Project: **PROPOSED NEW DISCOUNT FOODSTORE: LAND AT BARNARD ROAD, NORWICH**
PLANNING APPLICATION REFERENCE: 23/0165/f

Title: - **RESPONSE TO CONSULTATION RESPONSES ON ACTIVE TRAVEL AND PARKING**

Date: - **13 June 2024**

Client: Honeyview Investments	
Project: Land at Barnard Road, Norwich	
Drawing Title: Location of Pedestrian Improvements To the South of the Application Site	
Drawing Number: J000420-SK504	Revision: A
Date: 11/04/24	Scale: As Stated
Drawn By: APB	Checked By: -
Status: Information

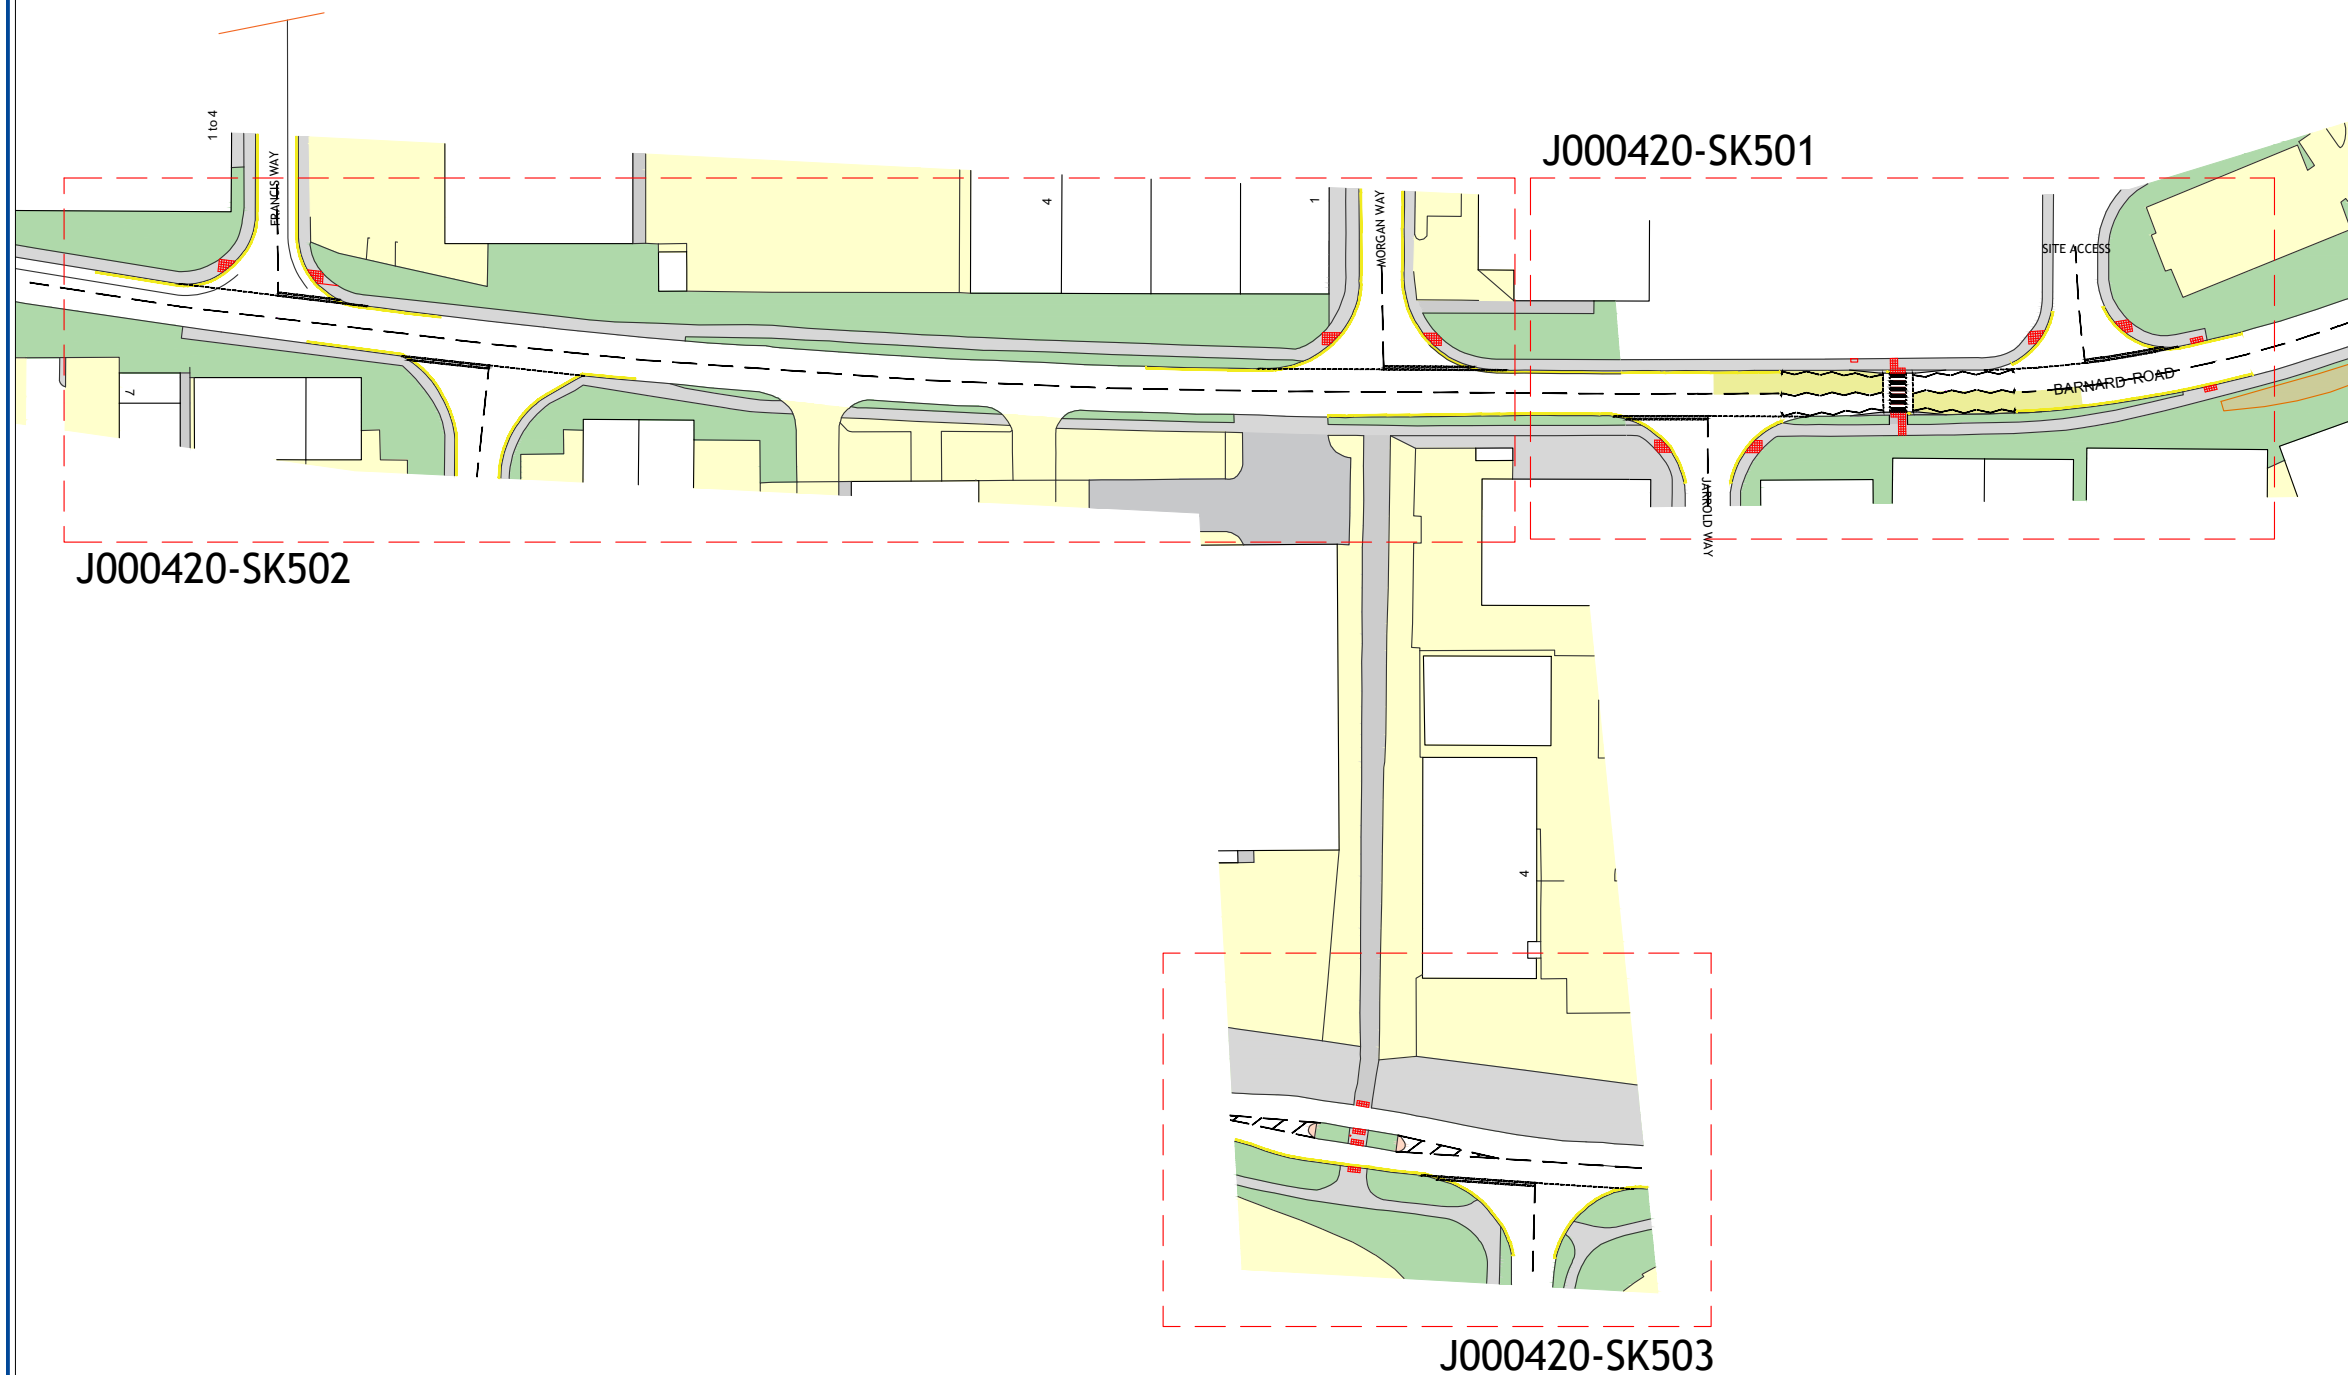
- The applicant was requested to investigate the extent of opportunities to improve active travel connections to the south of the site via Barnard Road, in particular connections to Mayfly Way & Bowthorpe centre, along with the safe crossing of Barnard Road itself and other local side road connections to this route. Any investigation should be informed by highway boundary information, supplied by NCC, to understand the extent of highway land available to deliver improvements.

- 2.10 Notwithstanding the above comments regarding the suitability of Barnard Road for regular walk / cycle access, it is acknowledged that there would be merit in delivering targeted improvements to infrastructure on Barnard Road and connecting links, in order to address existing deficiencies and, in particular, to maximise accessibility to the proposed food store site on foot. As noted there are currently limited pedestrian crossing facilities available within the immediate vicinity of the site, including at the site entrance connection to Barnard Road and at other surrounding linking side road junctions. The applicant has therefore worked up a proposed package of supporting pedestrian improvement works to promote improved active travel access, as set out below, (see also **Figure HTN4** for a plan of the location of such works and detailed layout drawings in **Appendix HTN4**).

- New Zebra crossing of Barnard Road (including minor narrowing (carriageway reduced to 6.5m) and raised speed table feature) to provide safe pedestrian crossing opportunities to Barnard Road in the immediate vicinity of the application site access. It is considered that the chosen location of this zebra crossing point is appropriate, with vehicle speed readings collected in the vicinity of the proposed crossing as part of the June 2024 ATC survey exercise, demonstrating that off-peak 85th percentile vehicle speeds in key approach directions are below critical 35mph thresholds (see **Appendix HTN5** to this report and summarised in **Table HTN2.2** below).

- Revision / extensions to existing double yellow line parking restrictions to local sections of Barnard Road to respond to the proposed new zebra crossing and to ensure safe large delivery vehicle access to / from the application site.
- New dropped crossings, including tactile paving, across the site access road connection to Barnard Road, plus an additional tactile crossing point of Barnard Way to the east of the application site access road junction, connecting to the current termination of the northern footway.
- New dropped crossing points and tactile paving across formal side roads connections to the northern side of Barnard Road (i.e. Francis Way & Morgan

- New dropped crossing point and tactile paving across the Jarrold Way side road to the southern side of Barnard Way, therefore improving pedestrian connections between the application site and the existing public footpath that links towards Chapel Break Road.

- Improved crossing point of Chapel Break Road (new tactile paving) and relocation of existing street lighting column to reduce conflict with pedestrian movements at this crossing. Again, to enhance links on foot between the site and Chapel Break Road / Bowthorpe and the local bus stops on nearby Astley Road (21, 21A & 26 bus services).

Drawing Title
Proposed Site Plan

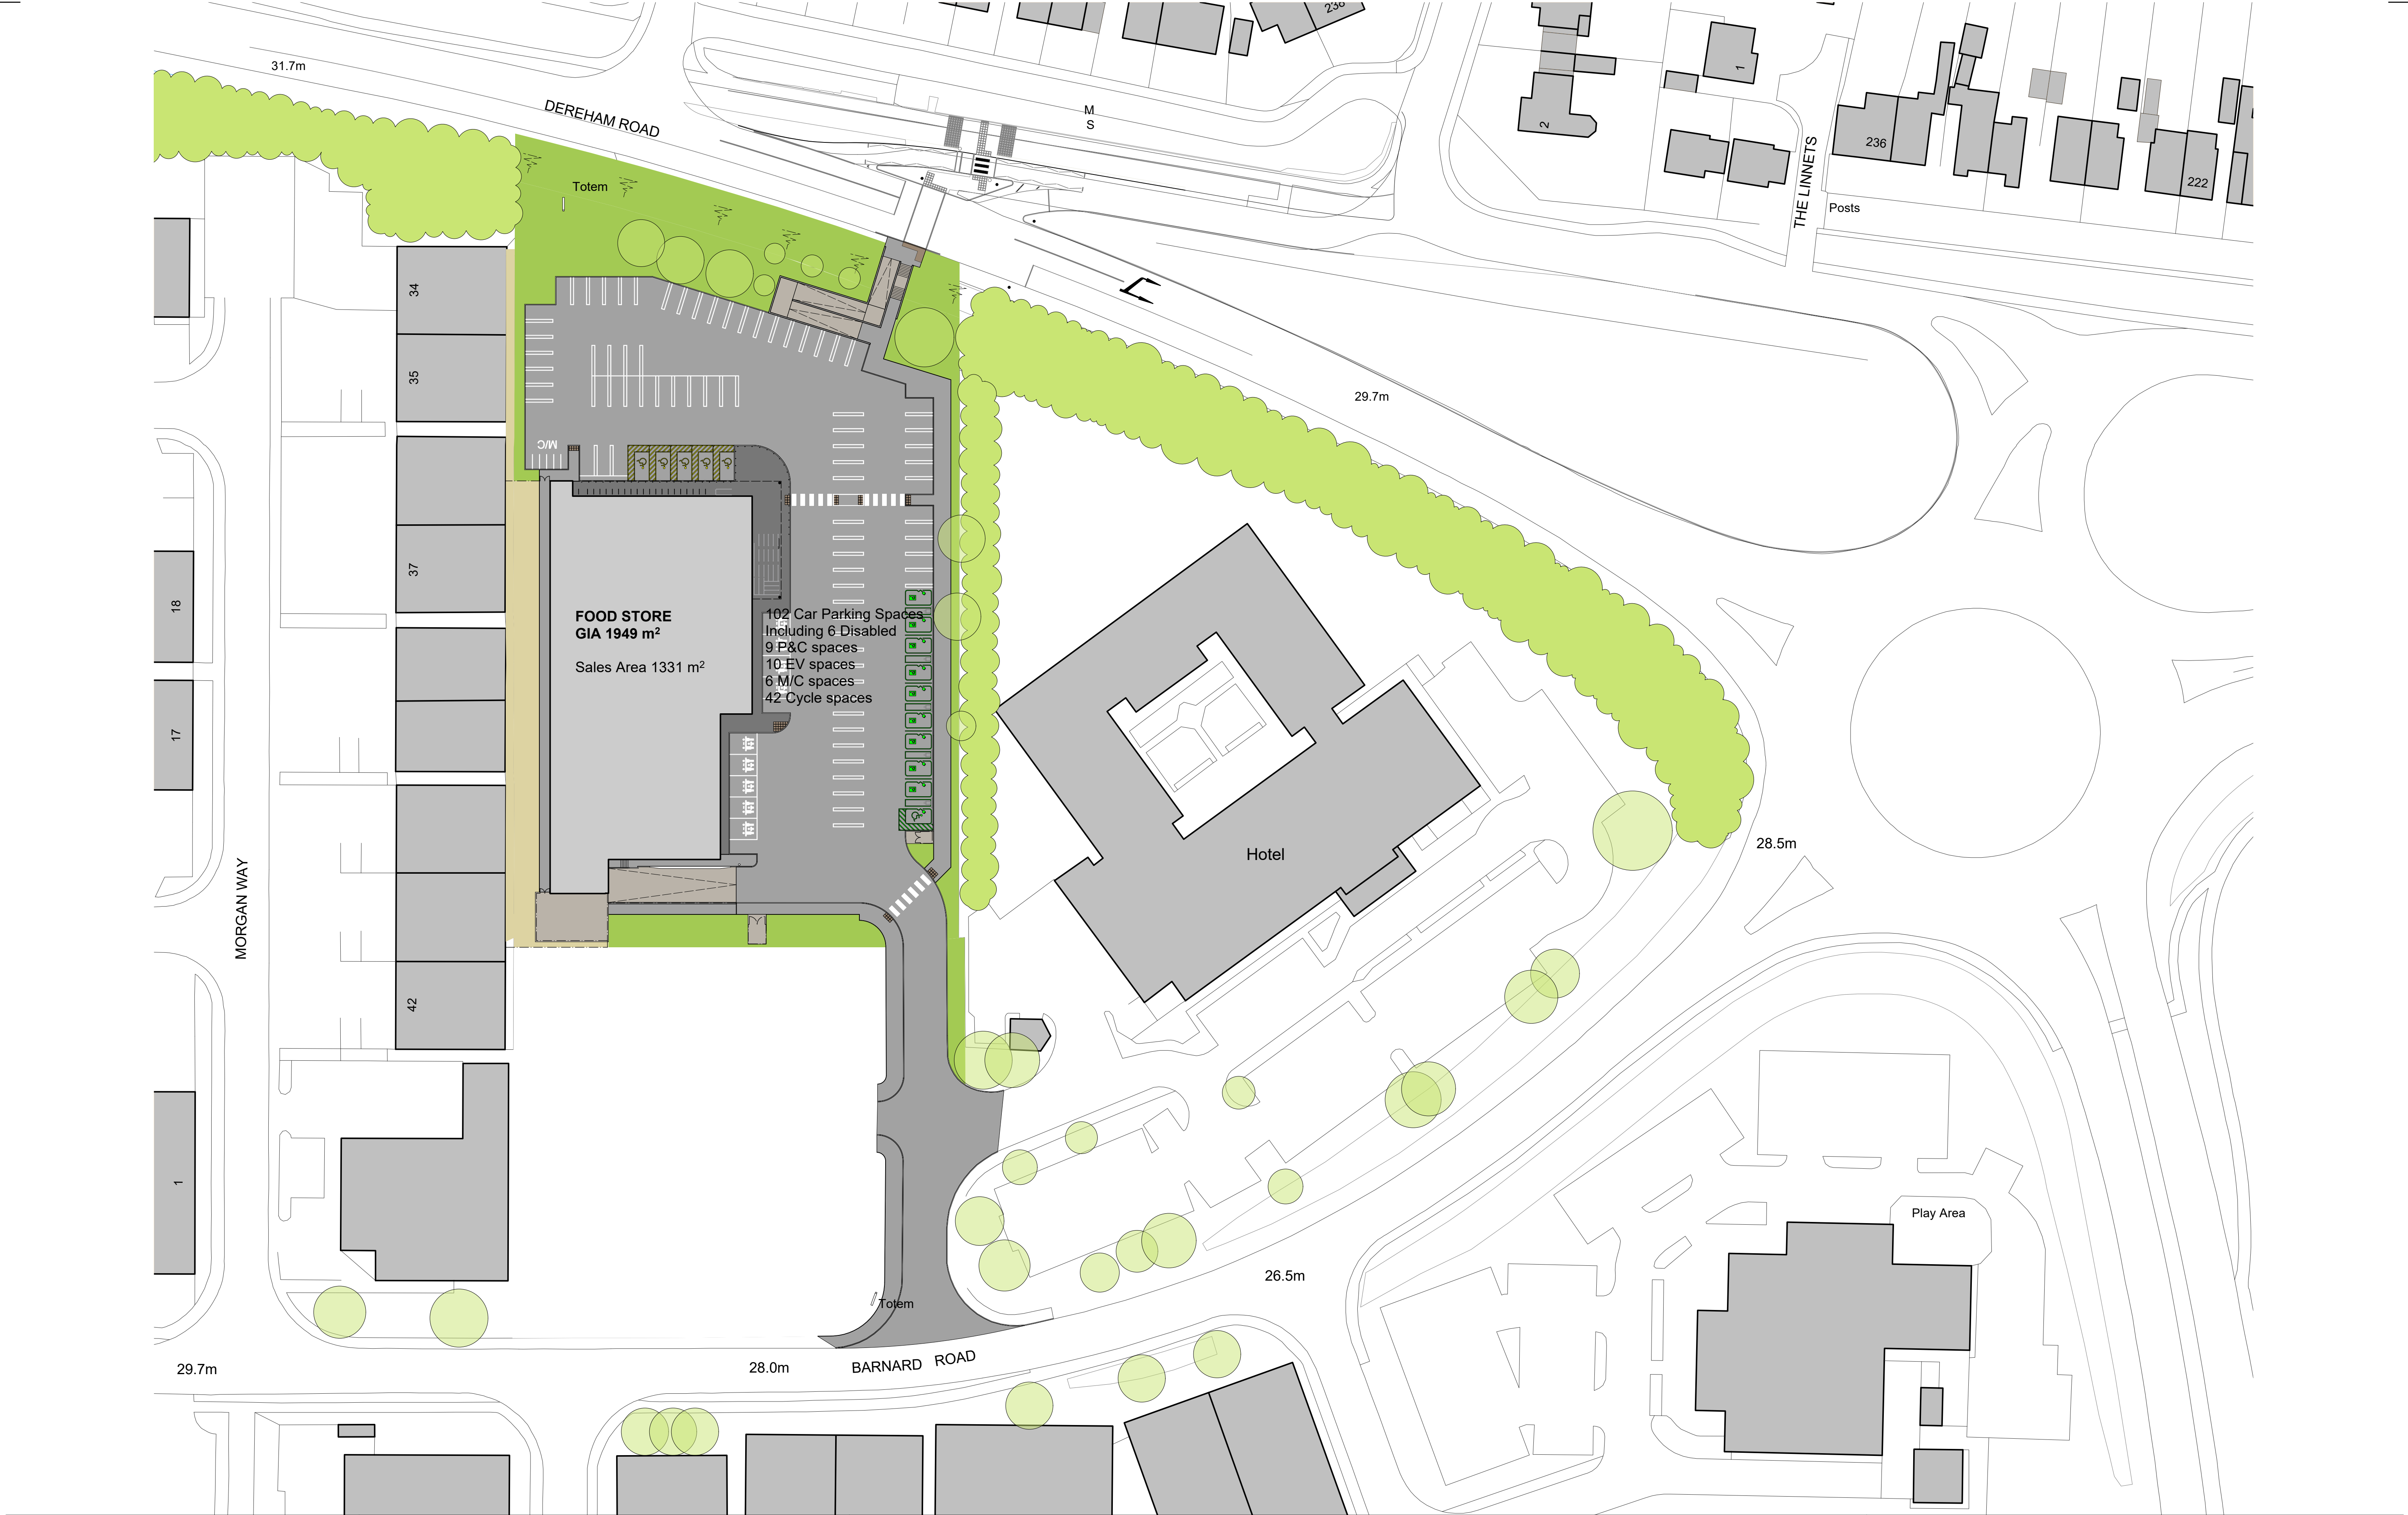
3.1 As noted in section 1 to this note, the March 2024 NCC consultation response identified that the highway authority considered that the general level of parking (both car & cycle parking) proposed to support the new food store scheme was suitable to meet NCC guideline requirements for parking to serve new development. Officers did, however, request that the applicant revisit the car parking layout with a view to providing additional EV parking.

3.2 The applicant has therefore revised the proposed car park layout in the light of this request, alongside other amendments to the location of the store building and associated changes to the northern boundary of the site to better accommodate the proposed walk / cycle ramp connection to Derwen Lane and minimise impact on existing trees / vegetation to the northern boundary of the site. This revised layout is included as C&W drawing ref 19408-301-P-03 to **Appendix HTN6**. Review of this amended layout illustrates the delivery of the following proposed level of parking to support the food store scheme:

- 102 car parking spaces (including 6 disabled spaces, 9 parent & child spaces, 10 EV standard spaces)
- 42 covered cycle spaces.
- 6 motor-cycle spaces.

3.3 The revised development parking scheme results in 15 fewer spaces in total, when compared to the original planning application proposals, but increases the number of proposed EV spaces, by 8 spaces (from 2 to 10, including 1 combined EV / disabled space), such that EV provision now represents 9.8% of total parking supply, broadly in line with NCC guidance. The remainder of the rear row of spaces will be constructed to include appropriate ducting to allow for future conversion to full EV spaces should this be identified as necessary in future, in response to increased EV demand levels.

3.4 It is noted that the revised level of total parking proposed across the site (102 spaces when compared to original planning submission layout of 117 spaces), is still well within the minimum parking requirements for food retail development as identified by Norfolk City Council within the parking standards set out in Appendix
